Surelock 5 upgrade

Centor E2 and E3 Hardware

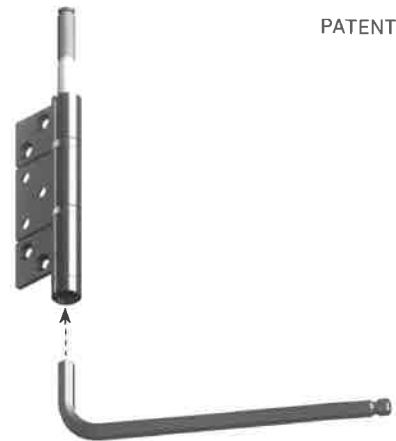
Centor's new Surelock 5 technology ensures folding doors running on E2 and E3 hardware can be adjusted simply with an Allen key.

Offering seven upgrades from the original version, the new Surelock 5:

1. Ensures adjustment is self evident with insertion of an 8mm Allen key into the end of the pin – now you can explain adjustment over the phone to your customers.
2. Removes the problematic yellow shipping clip found at the bottom of the pin – it can't be left in place after adjustment is finalised at installation.
3. Use of the Allen key provides more torque so the panel no longer needs to be 'unweighted' during adjustment.
4. Eliminates the locking wafer which had possibility of shifting off-centre and scratching the panel during adjustment.
5. Allows for one-handed adjustment with the Allen key.
6. Allows you to use an extended Allen key to adjust the door from ground level – a ladder or stool is no longer required making it safer for employees.
7. Looks great, thanks to the simplified design of the pin.

The introduction of Surelock 5 is a straightforward replacement of the pin in Centor's manufacturing process – it requires no change to your machining, ordering or pricing.
